| 8802-3/802.3 REVISION REQUEST 1222 |

DATE: 8th of March, 2010
NAME: Marek Hajduczenia
COMPANY/AFFILIATION: ZTE Corporation
E-MAIL: marek.hajduczenia@zte.com.cn

REQUESTED REVISION:
STANDARD: IEEE 802.3-2008
CLAUSE NUMBER: 64.3.3.6; 64.3.5.6
CLAUSE TITLE: State diagram; State diagrams

Figure 64–28—Gate Processing ONU Programming State Diagram

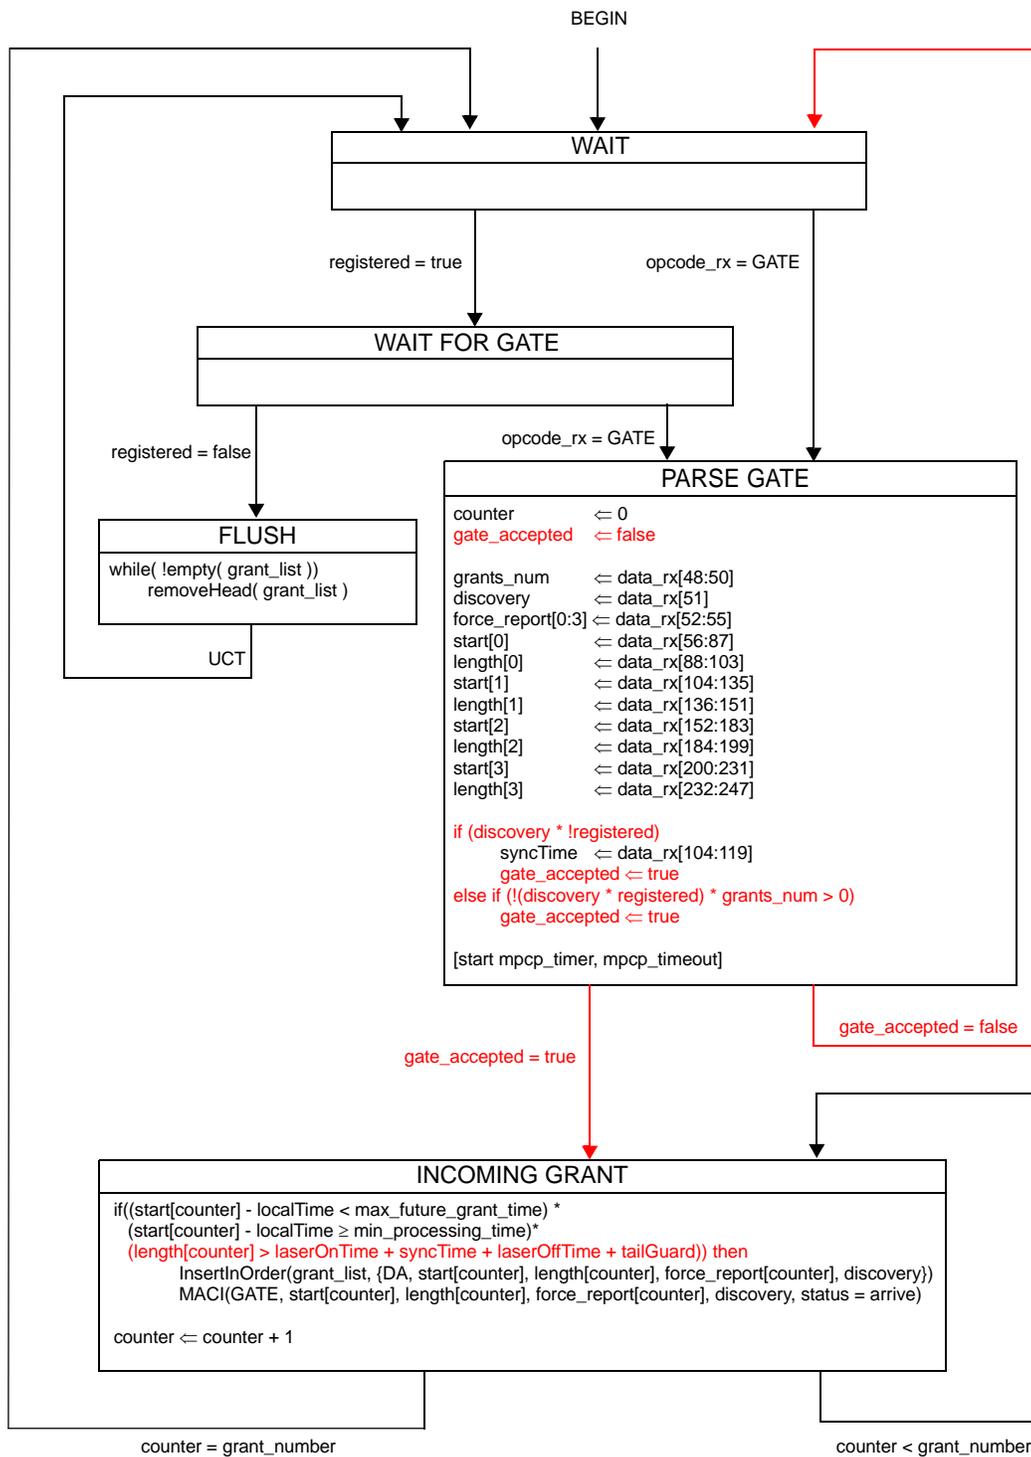
[2] Modify Figure 64-28 as presented in file "Attachment 1.pdf" - changes are marked in red. Removal of the CHECK NEXT GRANT state does not affect the observable behaviour of the state diagram but simplifies its analysis. Additionally, it aligns the styles of Figure 77-29 in IEEE Std. 802.3av-2009 and Figure 64-28 IEEE Std. 802.3-2008, aiding readability.

(3) OLT allocates a slot for this ONU, which will be processed according to Figure 64-28. The slot will be inserted into the slot queue

Figure 64–29—Gate Processing ONU Activation State Diagram

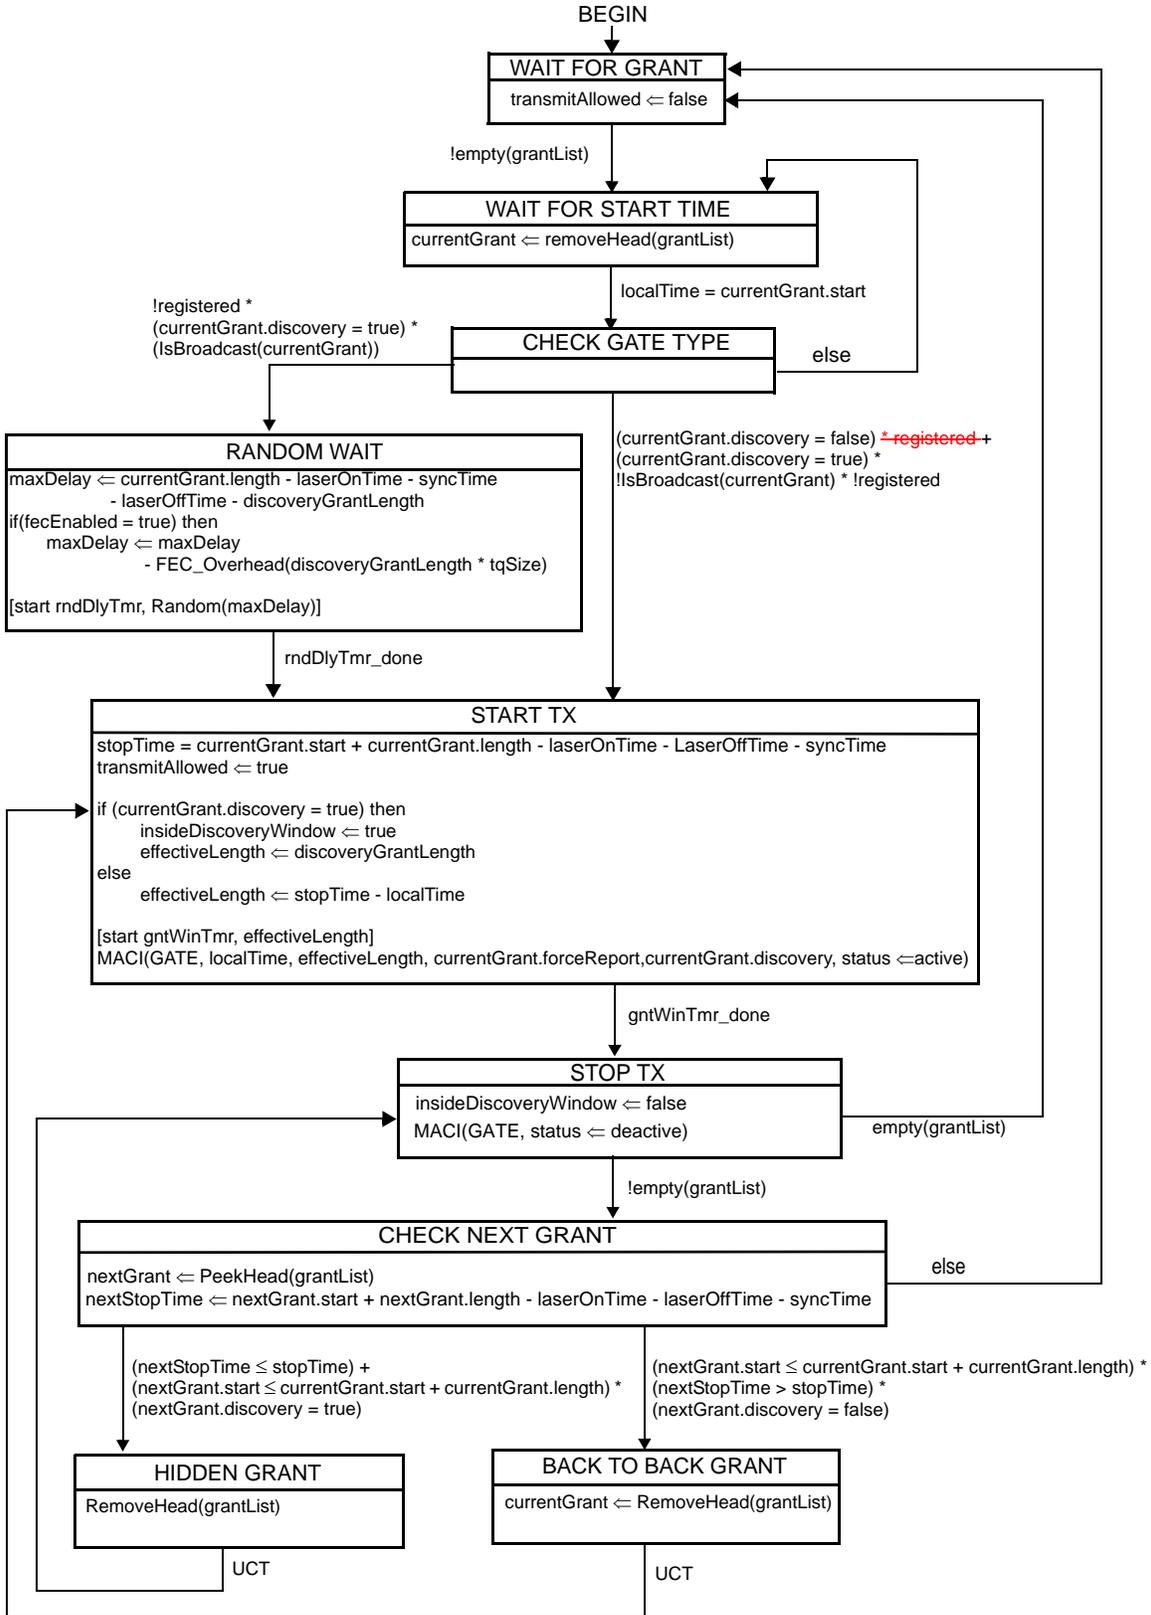
[3] Modify Figure 64-29 as presented in file "Attachment 1.pdf" - changes are marked in red.

(4) If the ONU MAC Client denied registration and register variable is false, all the transmission slots, received and stored in the slot queue according to the state diagram in Figure 64-28, will be dropped in the state diagram in Figure 64-29, since conditions (a) and (b) at the CHECK GATE TYPE state evaluate to false:

(a) !registered * (currentGrant.discovery = true) * (IsBroadcast(currentGrant))

(b) (currentGrant.discovery = false) * registered + (currentGrant.discovery = true) * !IsBroadcast(currentGrant) * !registered

This means that ELSE branch is taken and grant are effectively dropped.

(5) ONU cannot effectively send a REGISTER_ACK MPCPDU with NACK flag set, which prohibits it from notifying the OLT on NACK state on its side.
